DATE: 08.31.2017
TO: ProTrak
FROM: Bill McDow
 Transportation Planning

■ MAC'S SPEED SHOP [TRC Plan Review# 2]

↻ Initial Review Note ↻

TECHNICAL STANDARDS – DRIVEWAY ACCESS (Major Thoroughfares):

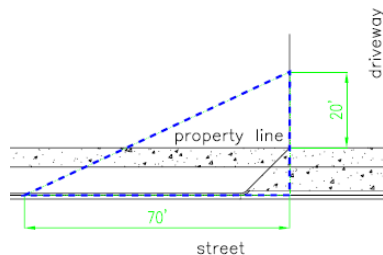
1. Driveways for lots along major thoroughfares must be at least 75' offset from property lines to the curb line. The existing Oleander Driveway will require a variance from the city engineer.
2. The minimum width of a two way driveway is 23' and the maximum width for a two way driveway is 30'. If the additional width is not required, the driveway width can be reduced. [7-9 CofW Tech Stds]
